## **Access Compliance Report Public Rights-of-Way** (Curb Ramps)

Intersection ID: 4866 Main Street: E\_MALLARD\_CREEK\_CHURCHCIROB's Street: N\_TRYON\_ST Location:

ADA ID: 8B155E3FD88B Ramp Type: Perp Initial Pass/Fail: Fail **Overall Compliance: No** Severity Score: 21.25

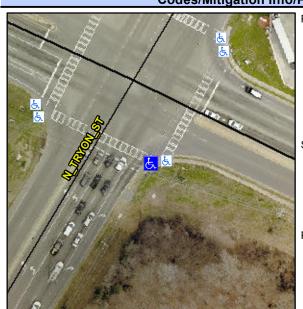
Field Measurements/Component Compliance					
Compliance Description		Data	Comp	liance Description	Data
N/A	Ramp Length (in)	60.0	Yes	Ramp Slope (%)	7.1
No	Ramp Width (in)	41.0	No	Ramp XSlope (%)	5.1
N/A	Flare Type LT	N/A	N/A	Flare Type RT	N/A
N/A	Flare Slope LT (%)	N/A	N/A	Flare Slope RT (%)	N/A
N/A	Flare Traversable LT?	N/A	N/A	Flare Traversable RT?	N/A
N/A	Landing Length (in)	N/A	N/A	DWS Provided?	N/A
N/A	Landing Width (in)	N/A	N/A	DWS Contrast?	N/A
N/A	Landing Slope (%)	N/A	N/A	DWS Length (in)	N/A
N/A	Landing X Slope (%)	N/A	N/A	DWS Full Width?	N/A
N/A	Landing Curb? (Y/N)	N/A	N/A	DWS Offset (in)	N/A
N/A	Shared Landing?	N/A			
N/A	Gutter Ponding?	N/A	N/A	Gutter Slope (%)	N/A
N/A	Gutter Lip Ht (in)	N/A	N/A	Gutter X Slope (%)	N/A
N/A	Painted X Walk1?	Yes	N/A	Painted X Walk2?	N/A
	X Walk 1 Direction	To NW		X Walk 2 Direction	N/A
N/A	X Walk 1 Width (in)	97.0	N/A	X Walk 2 Width (in)	N/A
	X Walk 1 Slope (%)	1.2		X Walk 2 Slope (%)	N/A

X Walk 1 X Slope (%)	2.5		X Walk 2 X Slope (%)	N/A
N/A	Ramp inside XWalk1?	Yes	N/A	Ramp inside XWalk2?	N/A
	Road Slope (%)	N/A	N/A	Clear Space?	N/A
	Road X Slope (%)	N/A	N/A	Clear Space to XWalk (in)	N/A
N/A	Any Obstructions?	N/A	N/A	Storm Grate/Utility Hazard?	N/A
	Obstruction Type			Storm Grate/Utility Type	
		N/A			N/A
			Yes	Surface Condition? (G/P)	Good
Re I

**NORTH TRYON ST** Street 1 Name Stop Condition-Street 2 Signal Street 2 Name N/A Stop Condition-Street 1 N/A Possible Solutions: Remove & Replace Entire Ramp. Surveyor Notes: N/A PROW/ADA: R304.5.1, R304.5.3
